SI B51 24 17
Body Equipment

RECALL 17V-328: E65/E66 (7 SERIES) DOOR LATCHES

This Service Information bulletin supersedes SI B51 24 17 dated February 2018

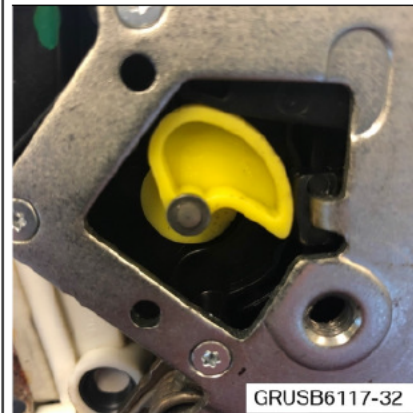
2. Once the door lock is removed, modify each lock by removing the white or yellow opening assist cam (red arrow).
3. **UPDATE!** If the door lock is replaced modify the new door lock as outlined below

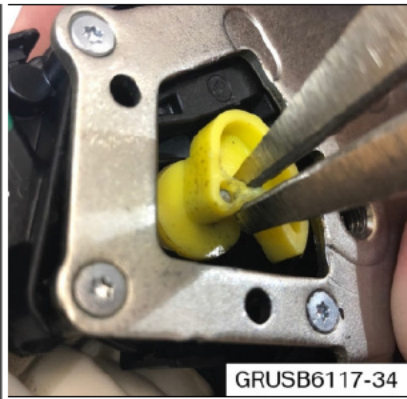
4. Manually position the cam so that it is clearly visible in the opening.

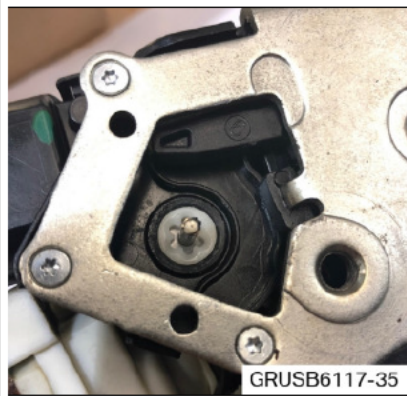
5. Cut the head of the cam retainer off with a pair of cutters.
